**RE: SADDLEHORN RANCH – FILING 1 – FIELD CHANGE NOTICE – DELETION OF CURTIS ROAD
DRIVEWAY CULVERTS**

SADDLEHORN RANCH -
 FILING 1
 CURTIS ROAD - STRIPING
 PLAN
 SHEET 7 OF 51
 JOB NO. 2514202

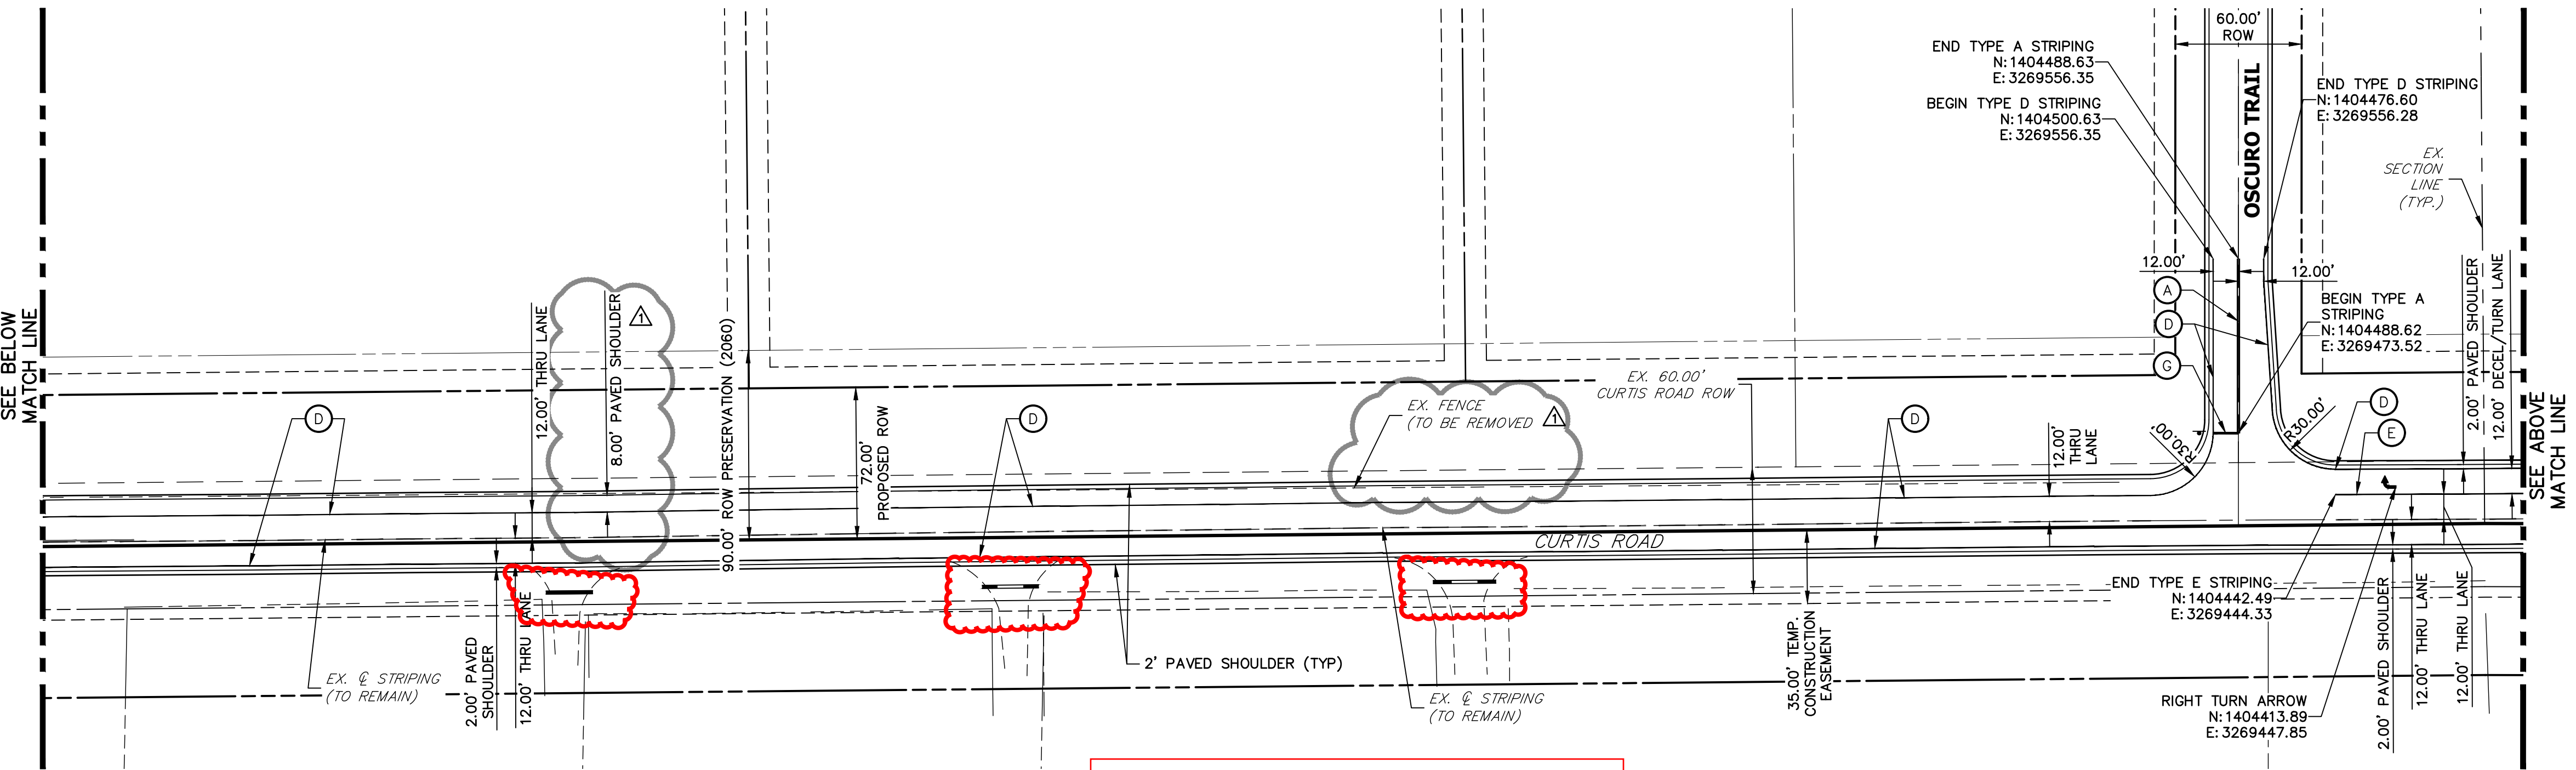
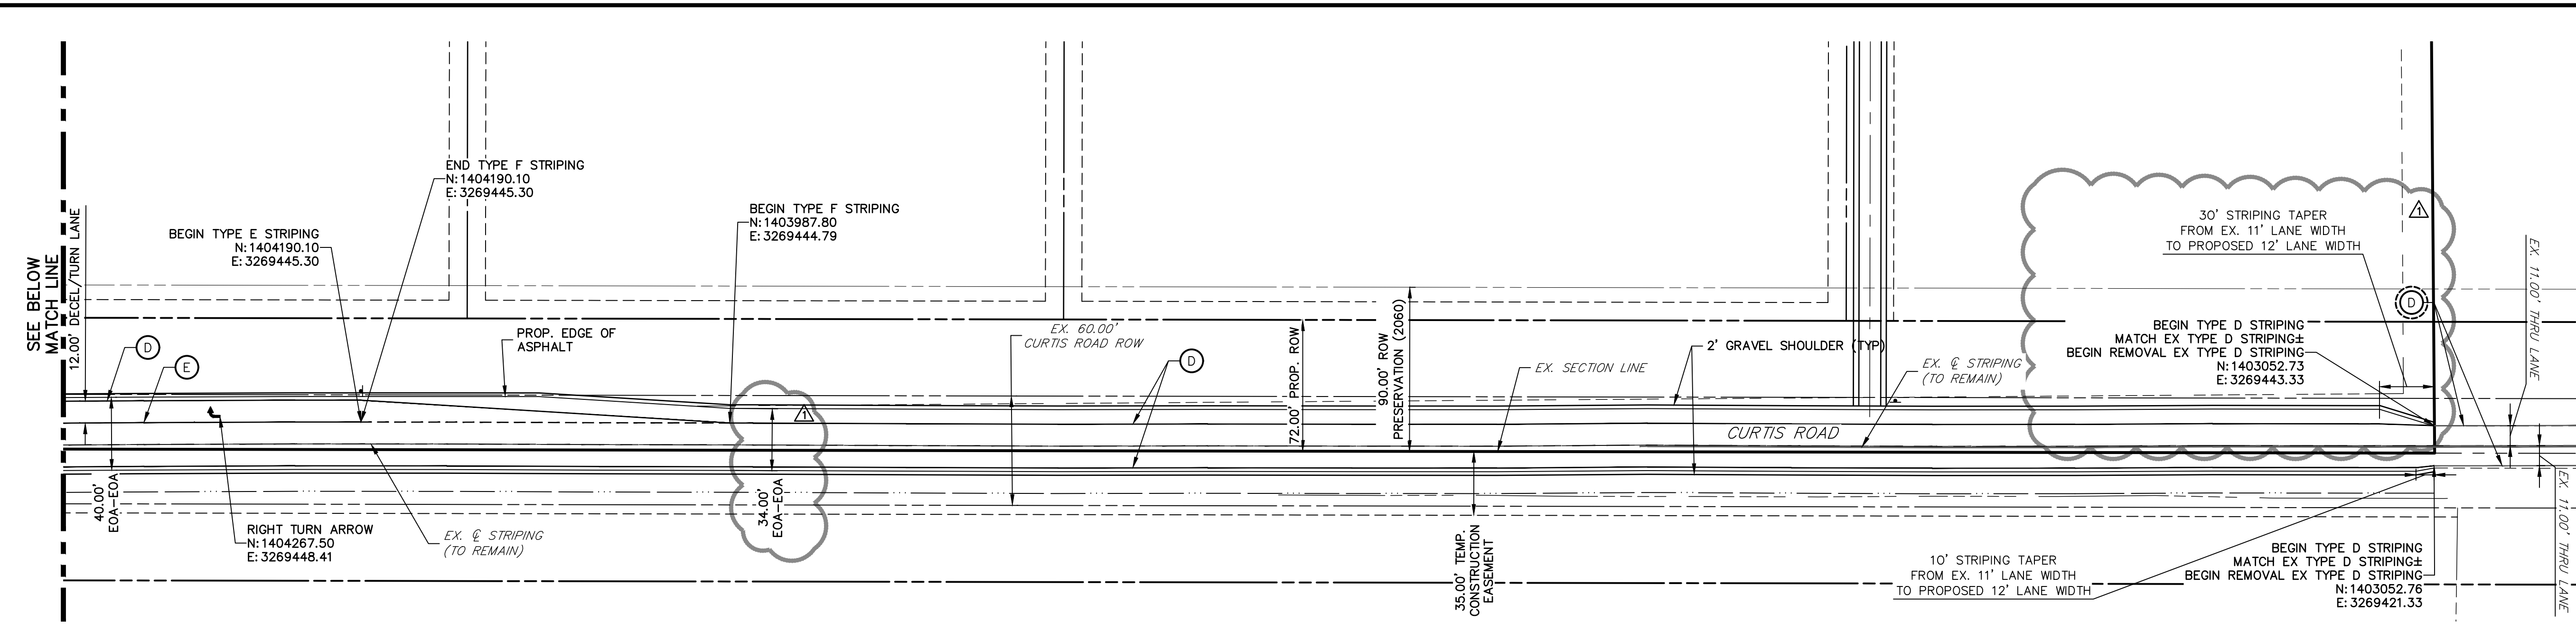
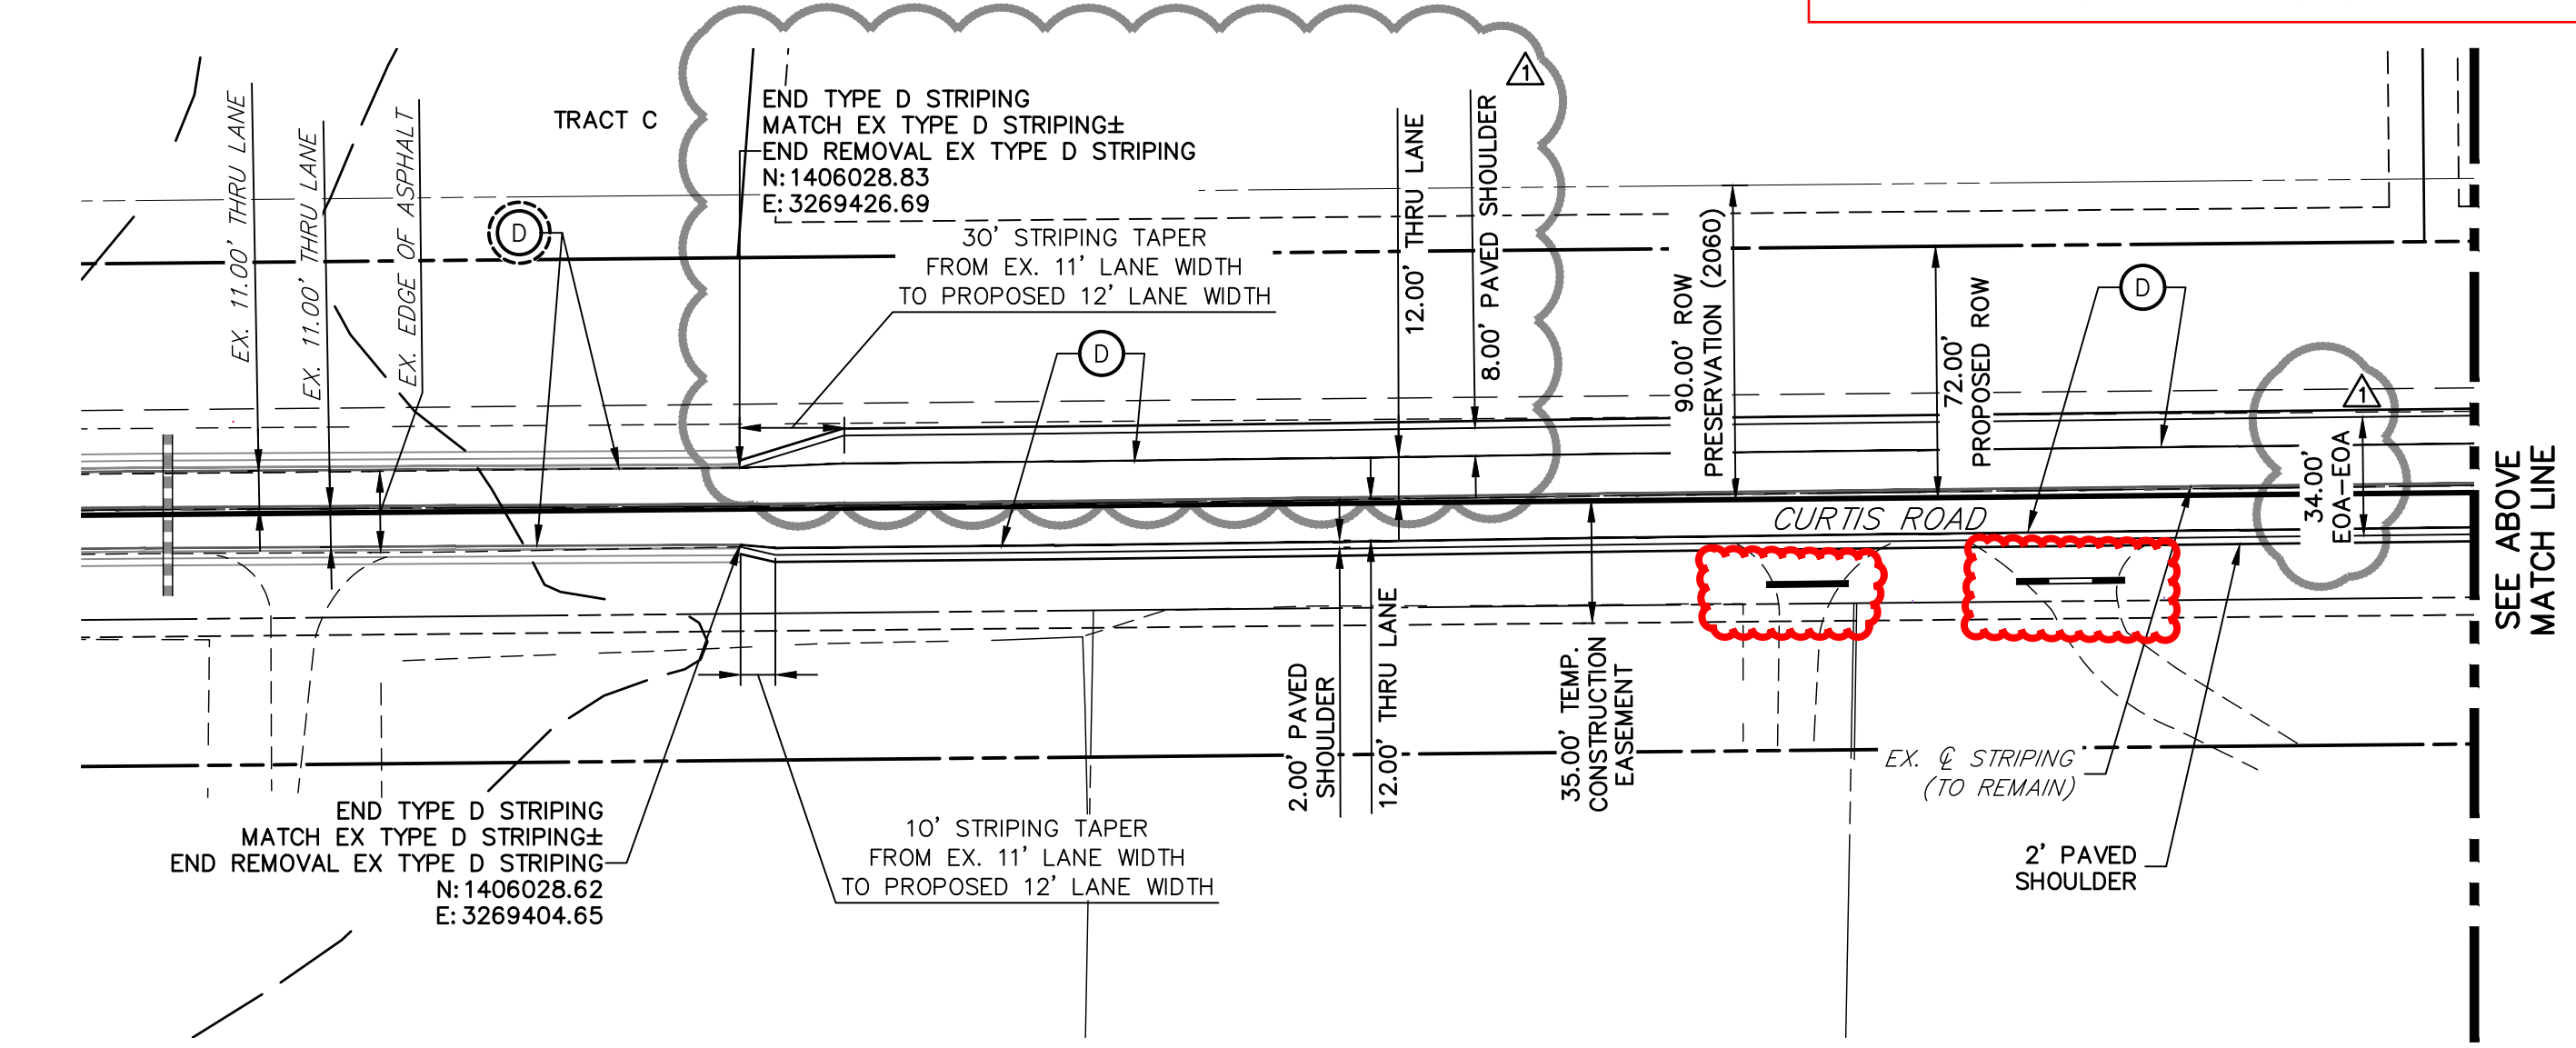
Please consider this field change notice letter for the Saddlehorn Ranch –Filing 1, located in Section 3 and 10, Township 13 South, Range 65 West of the 6th Principal Meridian in El Paso County, Colorado. JR Engineering has produced plans adding a total of 5 driveway culverts (see attached exhibit) along the west side of Curtis Road which per plan is to remain a 2’ shoulder. The east side is adding a lane/shoulder for the entire length of Saddlehorn Filing No. 1. The 5 drives currently do not have culverts and virtually no ditch.

Given that the County will obtain ROW in the future along the western side of Curtis to complete the planned full roadway section (to fit a 8’ wide paved shoulder) and the disruption the work would cause to neighbors by adding the culverts and ditches, JR Engineering requests that the culvert/ditchwork be eliminated from the project. It’s anticipated the ditch work and driveway culverts would be added at that time the ROW is acquired and the road widened by the County.

Culvert and ditch work to be removed
